CSB-1105-3
 Country : UK
 Date : 11/1/2006
 APC : ALL
 Repair Level : 3

Title RAZR V3i - GSM - GSM V3i - Alert - No Ringtone
 Model Effected All
PROBLEM

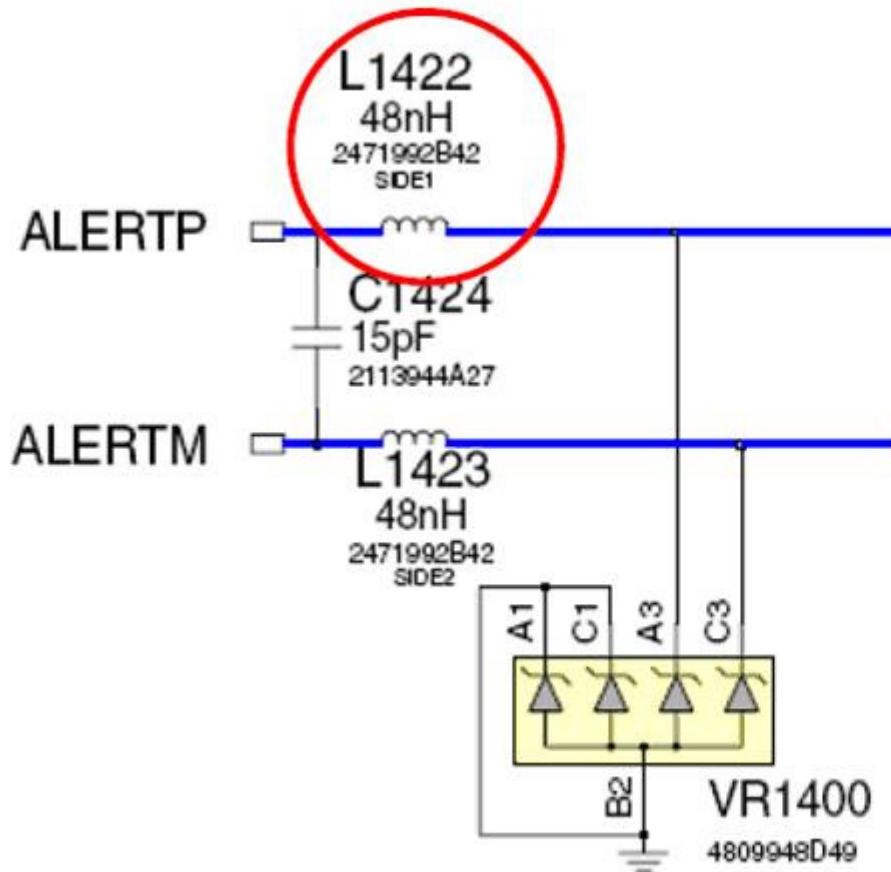
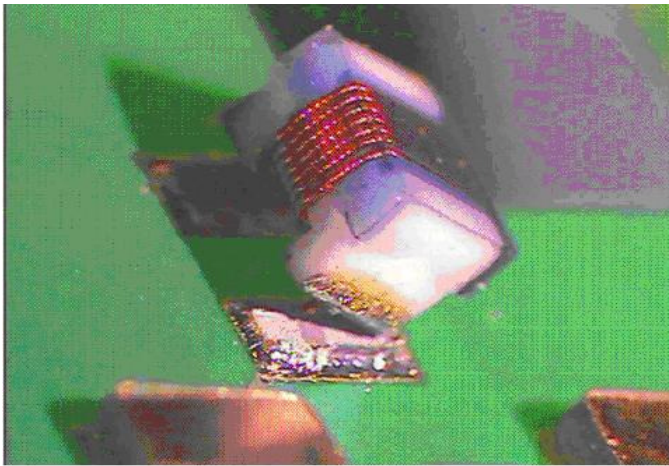
Service is aware that some GSM V3i phones from Brasil have been returned with customer complaints related to Alert – No Ring. The failure mode analysis revealed that the inductor L1422, Part Number 2471992B42 is being damaged in the manufacturing assembly process, thus causing customer to notice a difficult with ringtones - no alert audio. See pictures below :

Field solution is to replace the L1422 inductor damaged, missing or misplaced.

1. Verify customer complaint per normal procedure.
2. If customer complaint is confirmed, verify if the inductor L1422, Part Number 2471992B42 is misplaced, broken or missing, according to pictures above.
3. If L1422 is misplaced, broken or missing, proceed the replacement of L1422 as per service procedures.
